ECE/TRANS/WP.29/2008/84
25 July 2008

World Forum for Harmonization of Vehicle Regulations

Proposal for Supplement 32 to the 03 series of amendments to Regulation No. 37
(Filament lamps of power-driven vehicles and their trailers)

Submitted by the Working Party on Lighting and Light-Signalling (GRE) */

Sheet PC16W/1

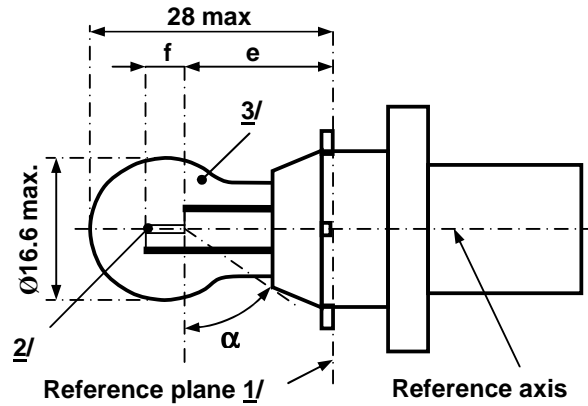
Insert new sheets PC16W/1 to 3, between sheet P27/7W/3 and sheet PR21W/1, to read:

- 1/ The reference plane is defined by the meeting points of the cap-holder fit.
- 2/ No actual filament diameter restrictions apply but the objective is $d_{max} = 1.1$ mm.
- 3/ The light emitted from normal production lamps shall be white for category PC16W; amber for category PCY16W; red for category PCR16W. (see also note 7/).

Sheet PC16W/2

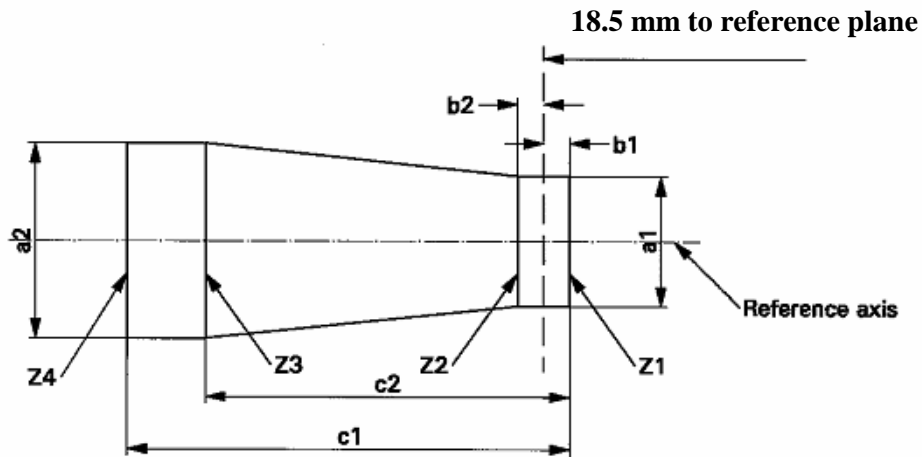
Dimensions in mm		Filament lamps of normal production			Standard filament lamp
		min.	nom.	max.	<u>7/</u>
e	<u>4/ 5/</u>		18.5		18.5
f	<u>4/ 5/</u>		4.0		4.0 ± 0.2
α	<u>6/</u>	54°			54° min.
PC16W	Cap PU20d-1	in accordance with IEC Publication 60061			
PCY16W	Cap PU20d-2	(sheet 7004-[...]-1)			
PCR16W	Cap PU20d-7				
ELECTRICAL AND PHOTOMETRIC CHARACTERISTICS					
Rated values	Volts	12			12
	Watts	16			16
Test voltage	Volts	13.5			13.5
Objective values	Watts	17 max.			17 max.
	Luminous flux	PC16W	300 ± 15 %		
		PCY16W	180 ± 20 %		
		PCR16W	70 ± 20 %		
Reference luminous flux at approximately			13.5 V	White: 300 lm Amber: 180 lm Red: 70 lm

4/ The filament position is checked by means of a "Box-System"; sheet PC16W/3.

5/ The ends of the filament are defined as the points where, when the viewing direction is perpendicular to the plane through the filament lead-in wires as showed in the drawing on sheet PC16W/1, the projection of the outside of the end turns crosses the filament axis.
